SIB 61 01 20

2023-02-13

ACCESSORIES DO NOT POWER UP FROM THE FRONT 12 V POWER SOCKET PLUGThis Service Information Bulletin (Revision 7) replaces SI B61 01 20 **dated November 2022**.**What's New** (Specific text highlighted):

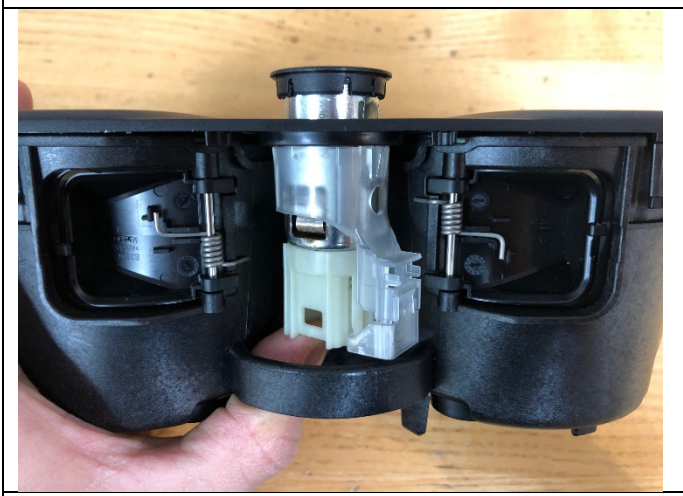
A design change was intended to reduce short circuits and blown fuses. When the plug adapter is inserted, the center contact pin may not make proper contact with the center pin of the power socket plug.

- Replace the plug-in socket (new design and repair procedure)

IMPORTANT: The procedure to install this newly designed component will remove the functionality of the cigarette lighter and the ambient ring lighting if equipped.**PROCEDURE**

1. Remove the center cupholder.

2. Push the original plug-in socket from the bottom up.

3. Install new plug-in socket by sliding from the top section of the cupholder.

4. Reinstall cupholder and test system for proper operation.
